**C-18 McCullough Avenue Sewer Replacement Project**  
**Solicitation Number: CO-00390-SM**  
**Job No.: 17-4555**

**ADDENDUM 2**  
**December 17, 2020**

SHEET NO. **C-18**  
 36 OF 74

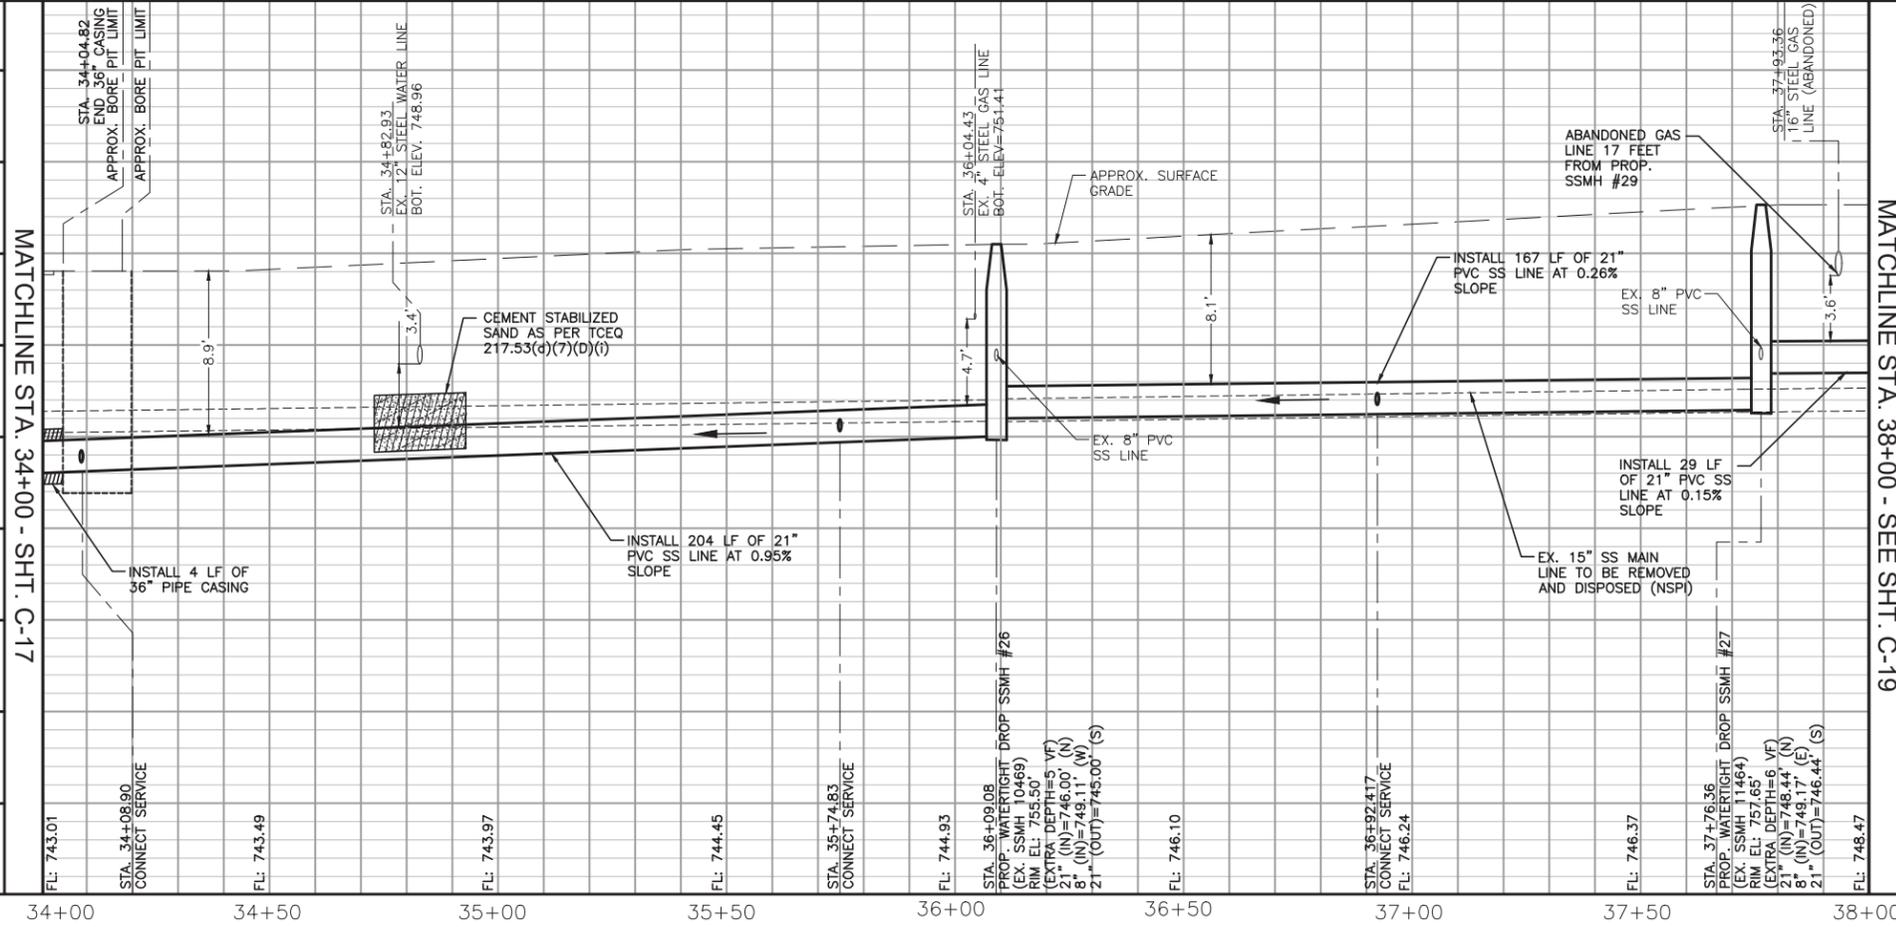
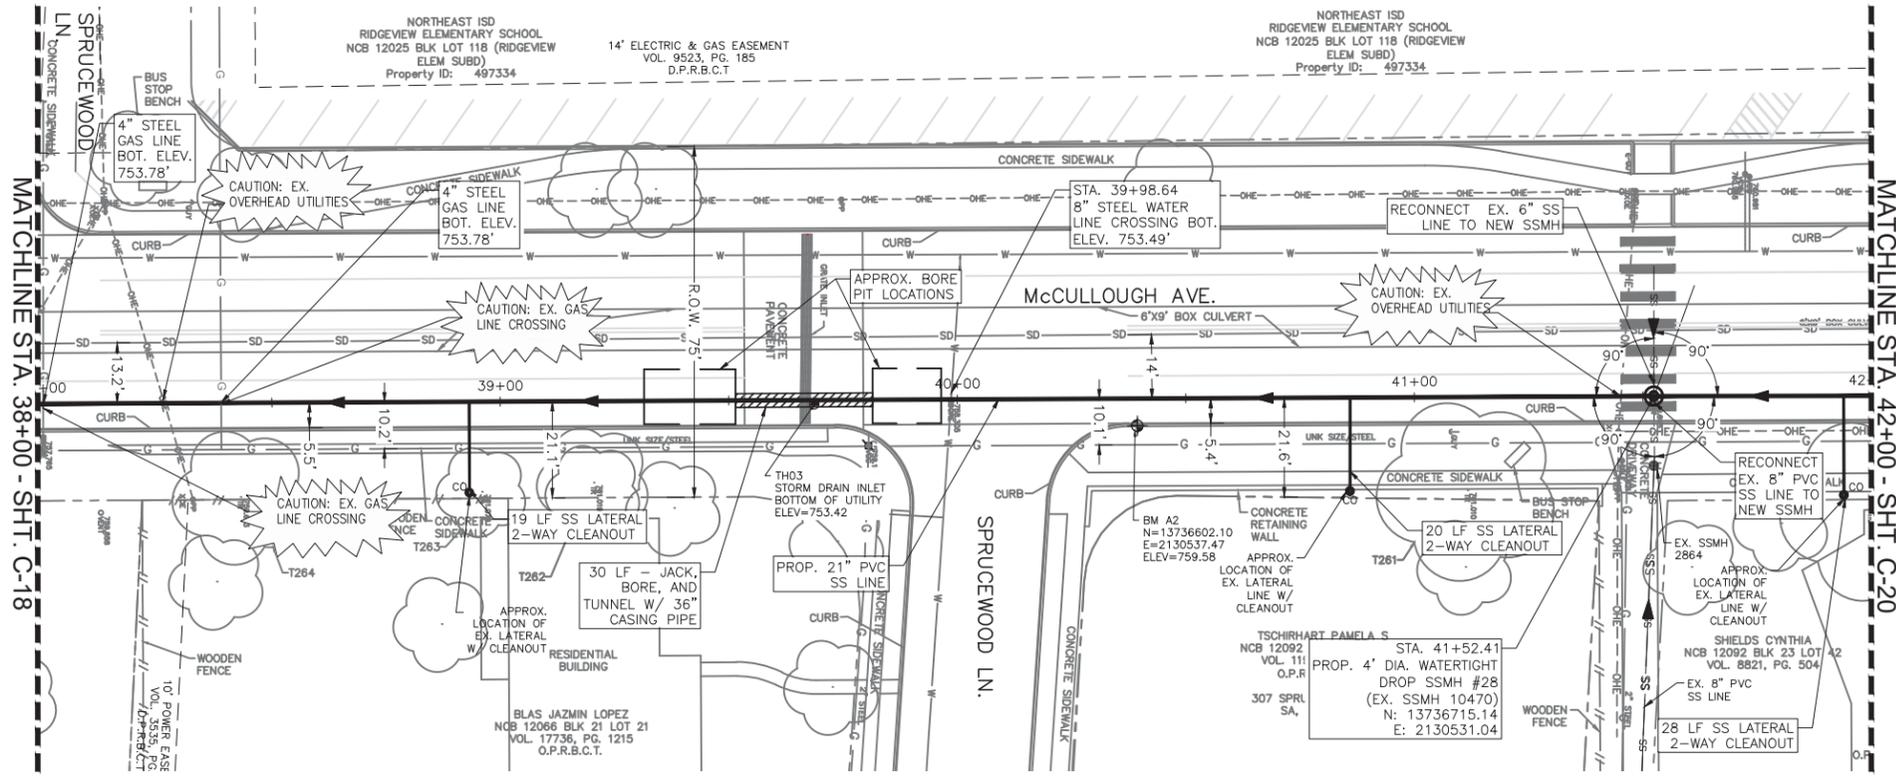
10. Plan Sheet C-18: Line item “858 concrete encasement, cradles, saddles” is removed in its entirety. Concrete encasement, saddles, cradles and collars shall be subsidiary to pipe installed. No separate pay item. Cement Stabilized Sand shall be in compliance with TCEQ Code 217.53(d)(7)(D)(i) and shall be subsidiary to pipe installed. No separate pay item for cement stabilized sand.

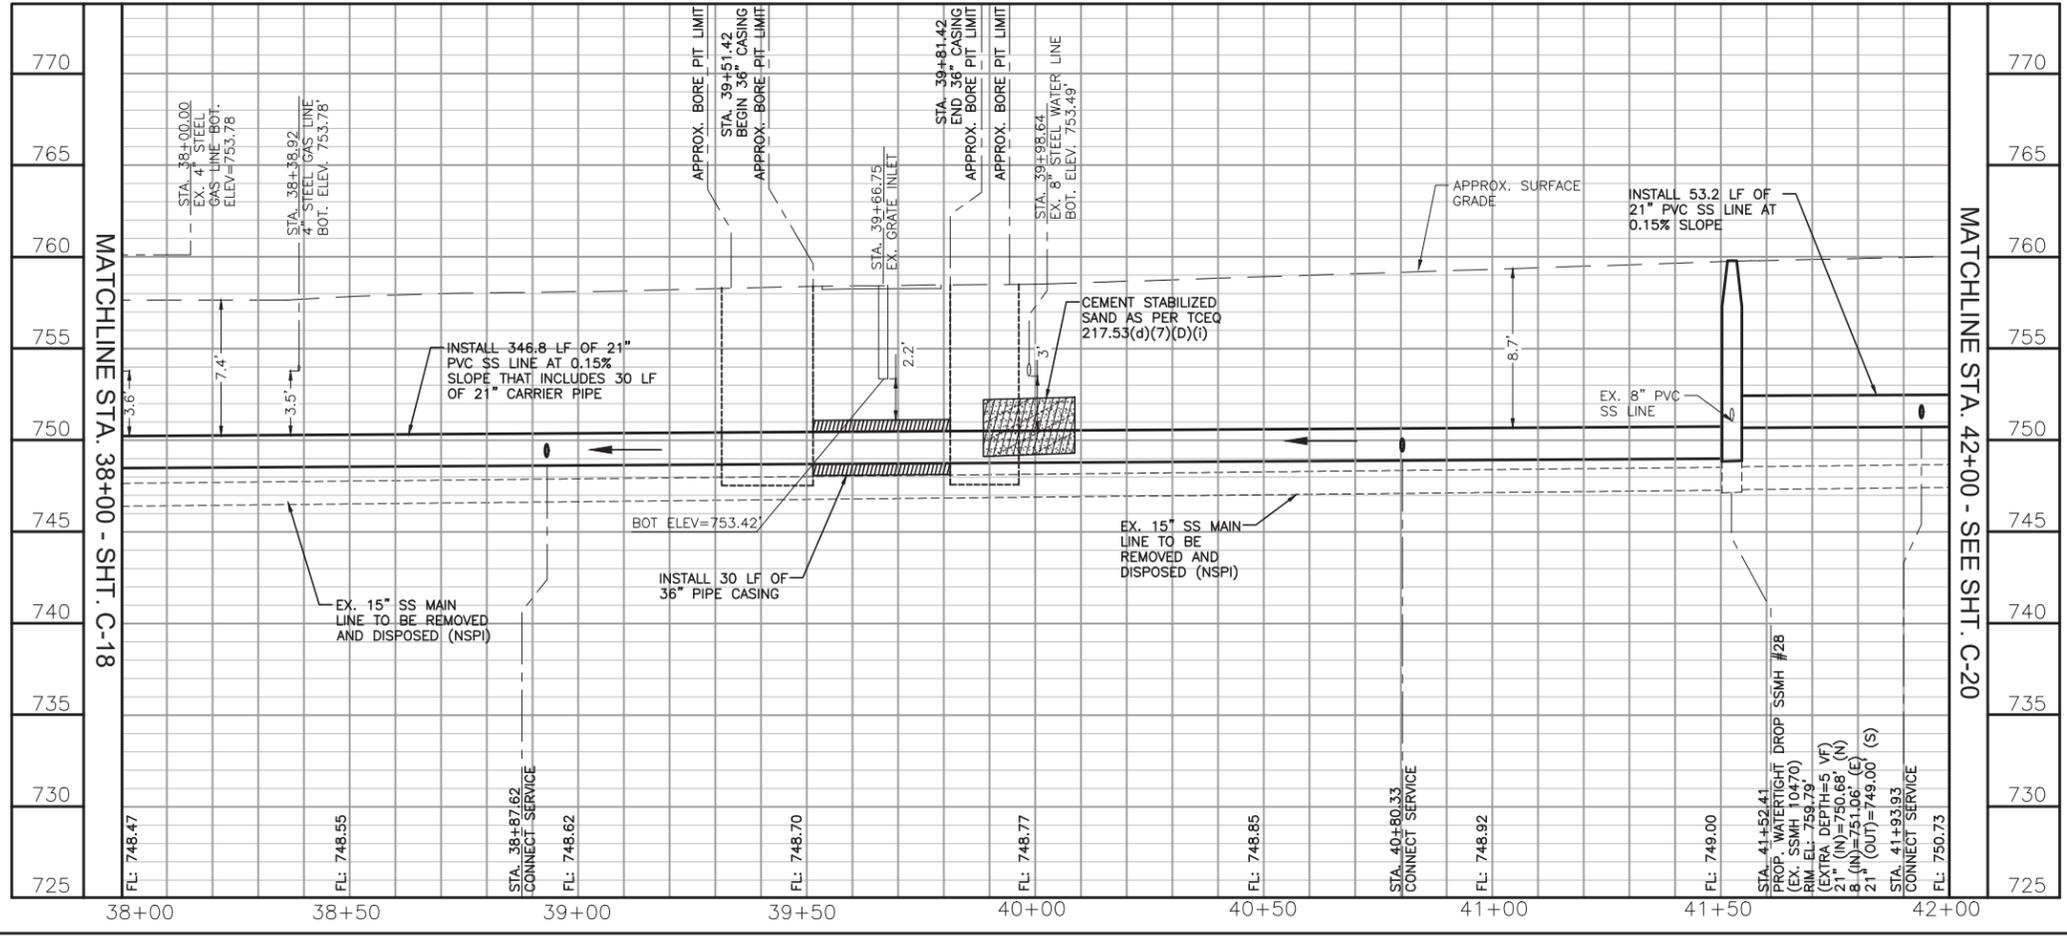
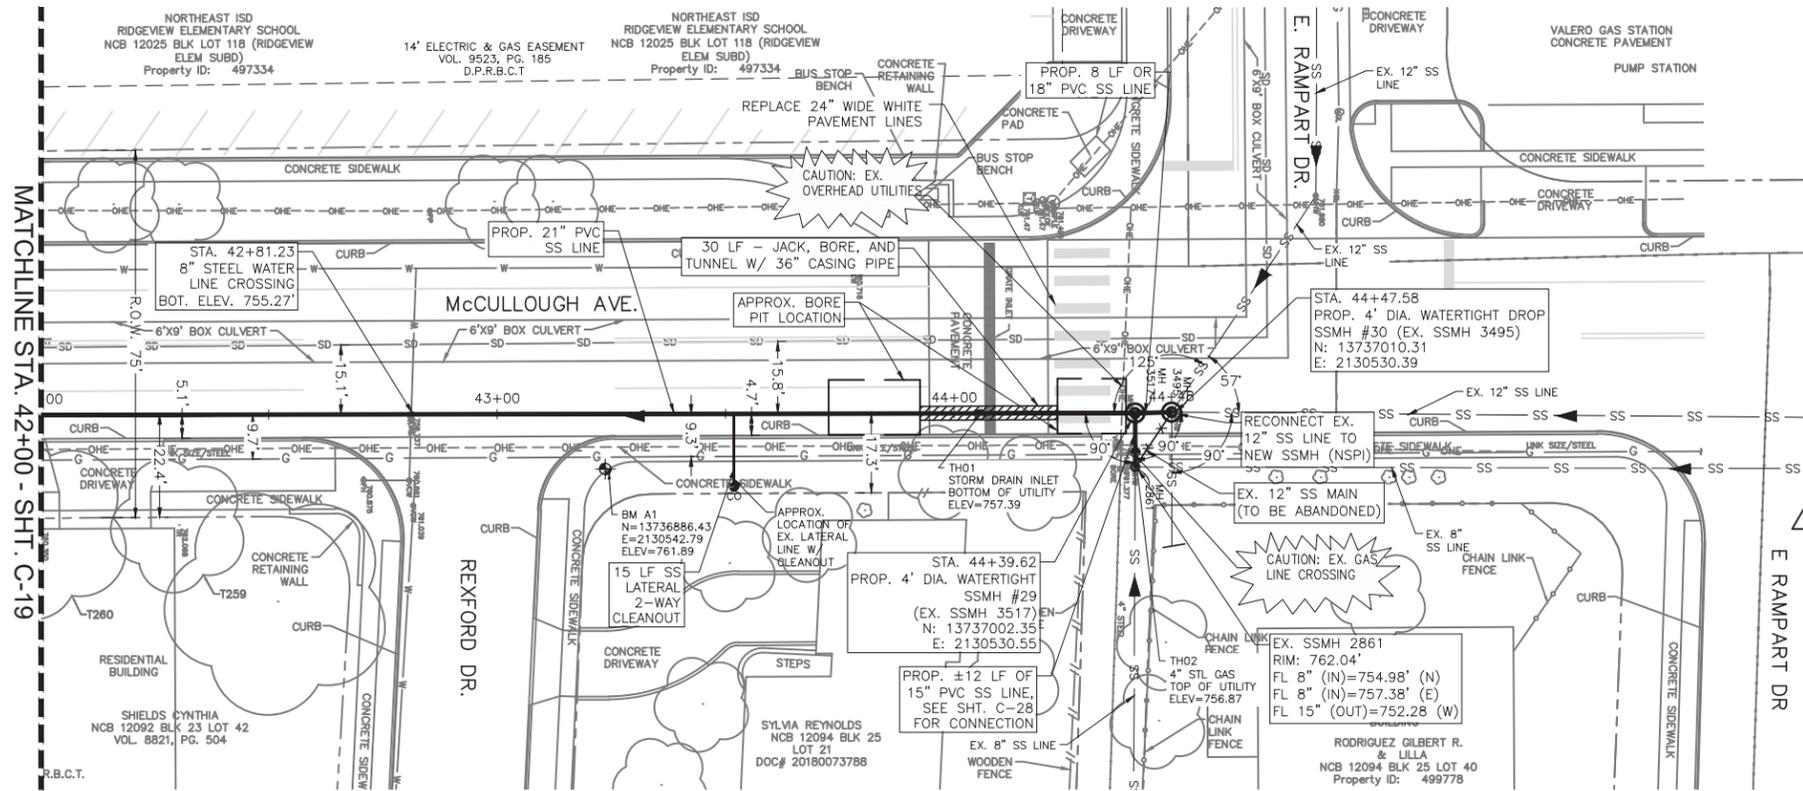
11. Plan Sheet C-19: Line item "858 concrete encasement, cradles, saddles" is removed in its entirety. Concrete encasement, saddles, cradles and collars shall be subsidiary to pipe installed. No separate pay item. Cement Stabilized Sand shall be in compliance with TCEQ Code 217.53(d)(7)(D)(i)) and shall be subsidiary to pipe installed. No separate pay item for cement stabilized sand.

SHEET NO. C-20  
38 OF 74

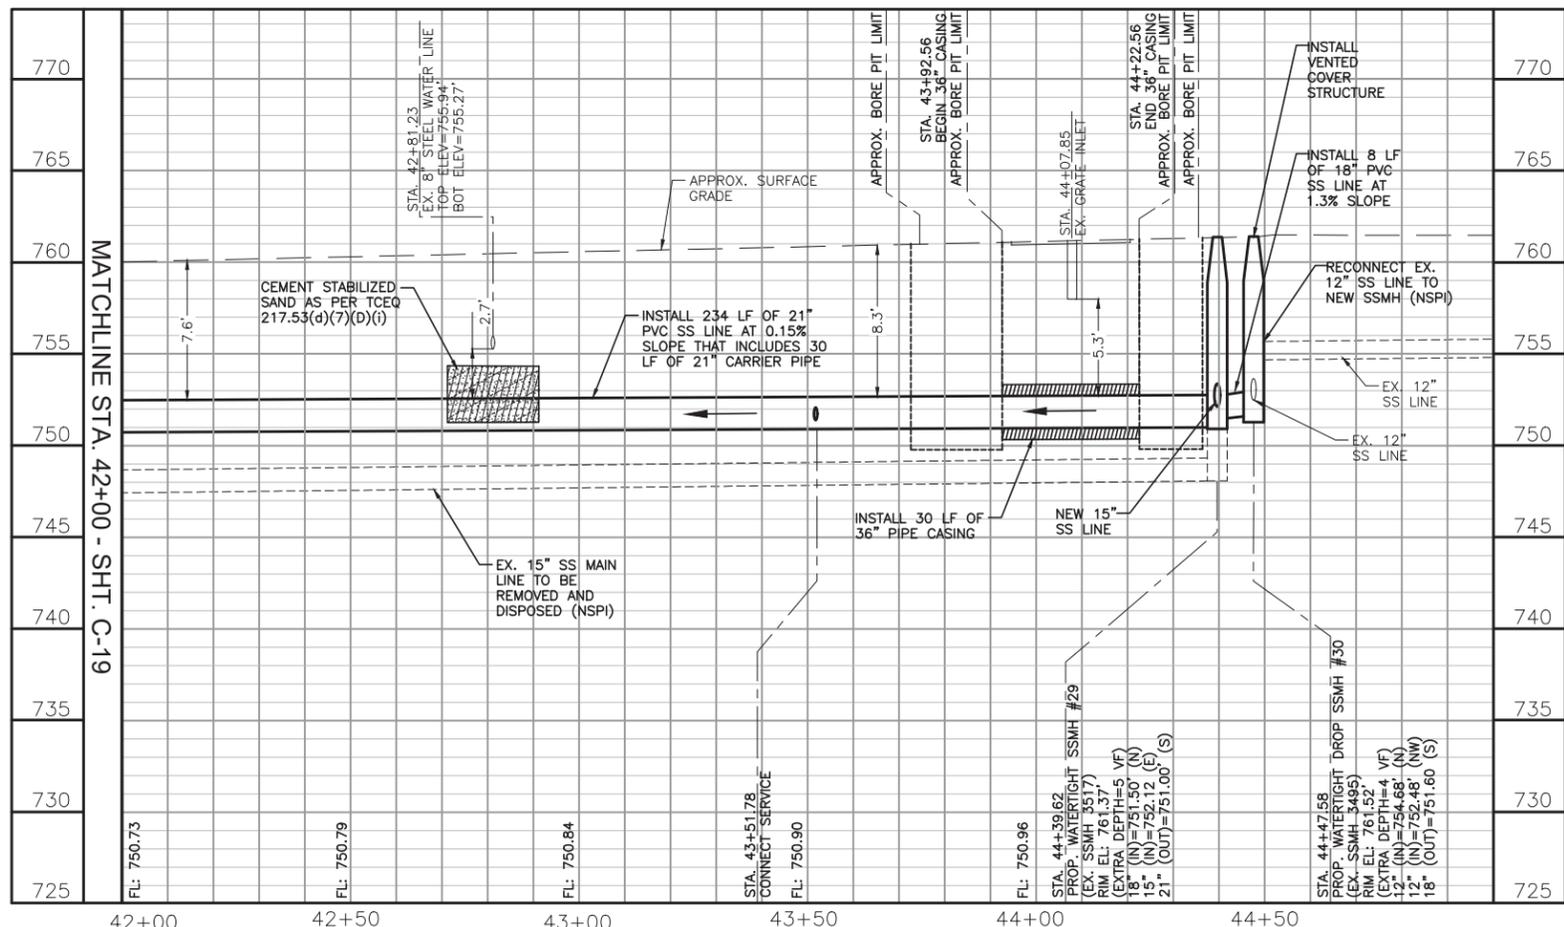
12. Plan Sheet C-20: Line item "858 concrete encasement, cradles, saddles" is removed in its entirety. Concrete encasement, saddles, cradles and collars shall be subsidiary to pipe installed. No separate pay item. Cement Stabilized Sand shall be in compliance with TCEQ Code 217.53(d)(7)(D)(i)) and shall be subsidiary to pipe installed. No separate pay item for cement stabilized sand.

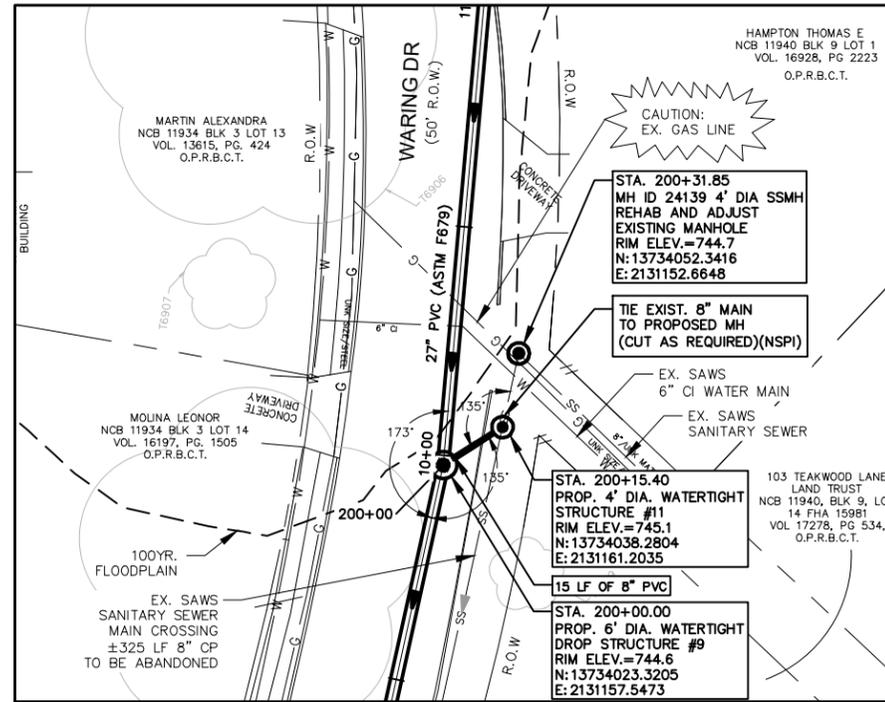
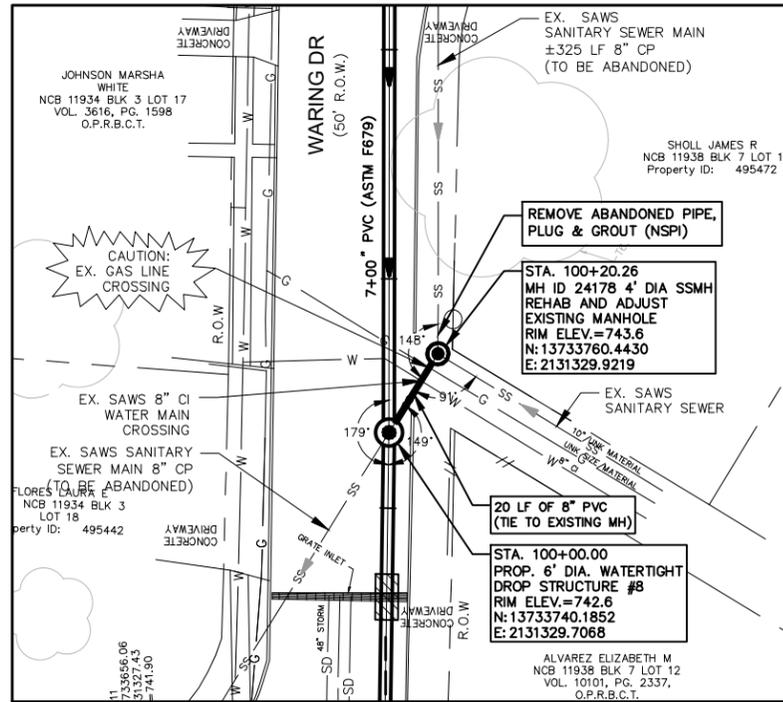
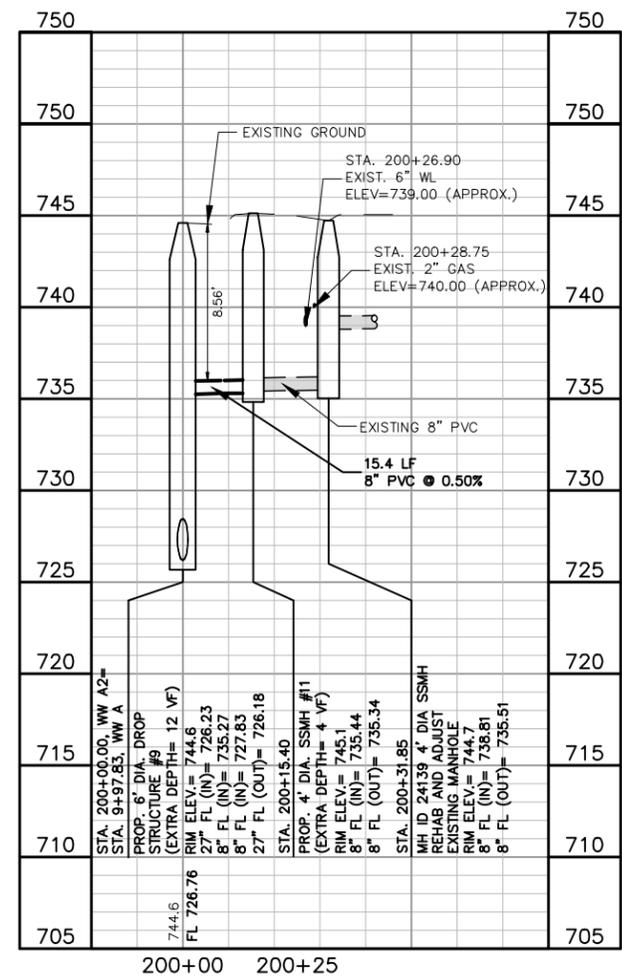
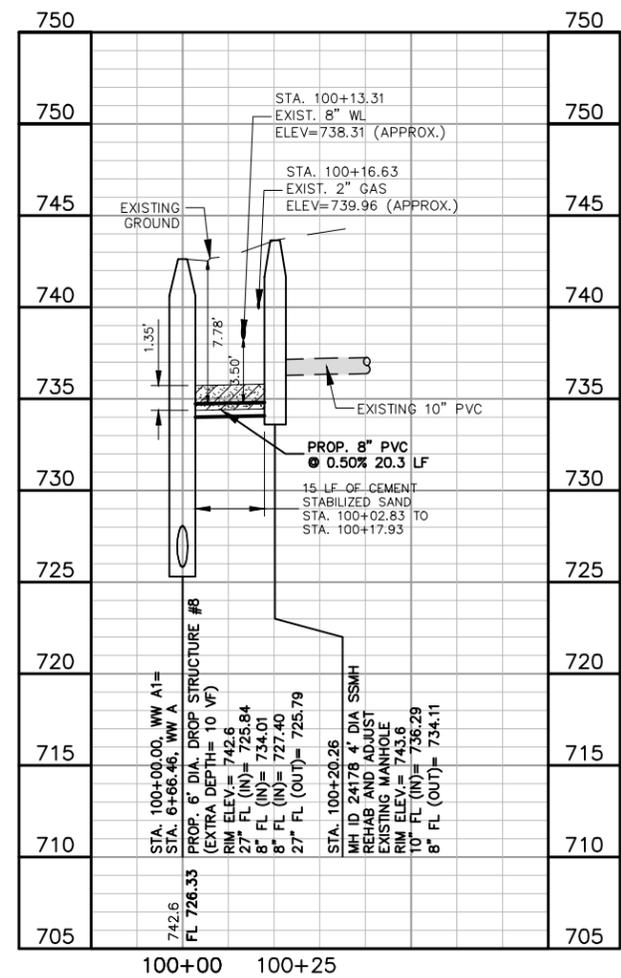
13. Plan Sheet C-29: Line item "858 concrete encasement, cradles, saddles" is removed in its entirety. Concrete encasement, saddles, cradles and collars shall be subsidiary to pipe installed. No separate pay item. Cement Stabilized Sand shall be in compliance with TCEQ Code 217.53(d)(7)(D)(i)) and shall be subsidiary to pipe installed. No separate pay item for cement stabilized sand.
